DRB-96-358
Amend ment to SPP
Subdivision

Altura Village

Revised set 6/24/97

Site Development Plan for Building Permit

ELEVATION A

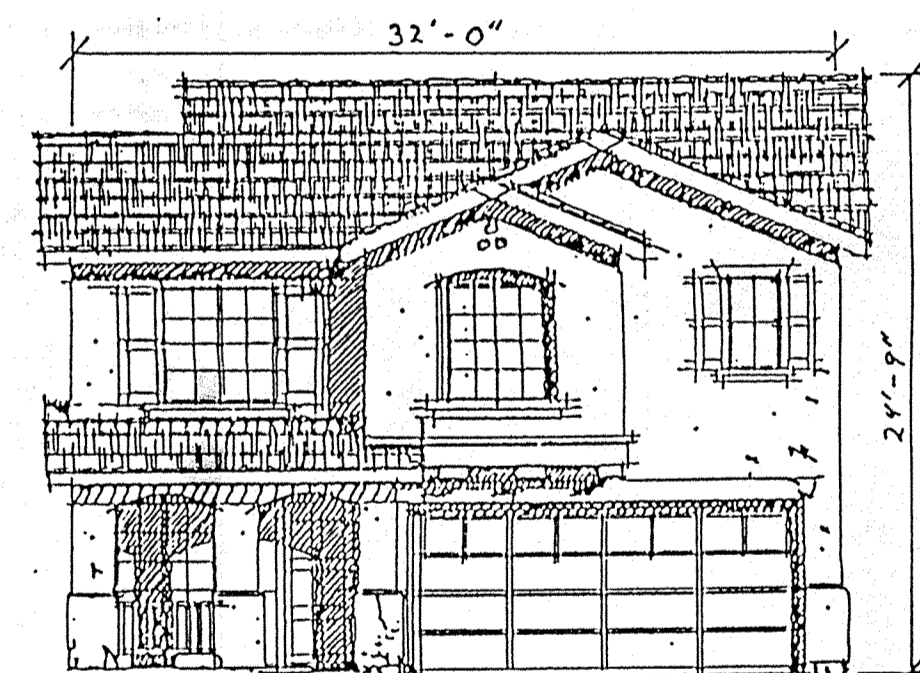
Doesn't match EPC Spanish mission approval

RIGHT ELEVATION

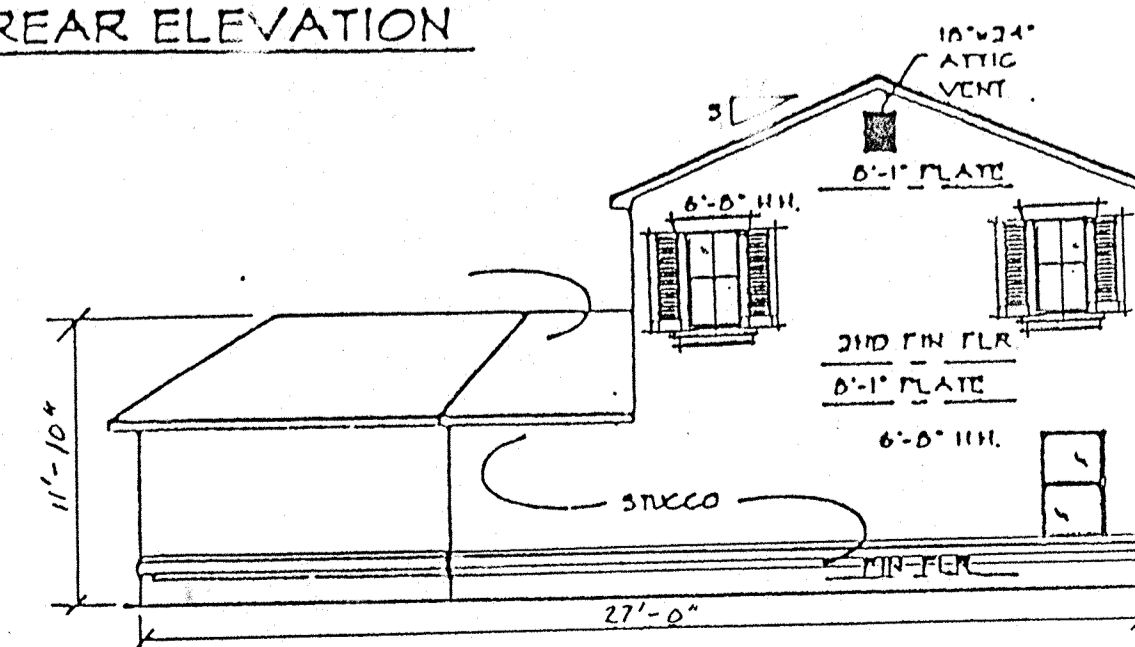
Not approved by E.P.C.
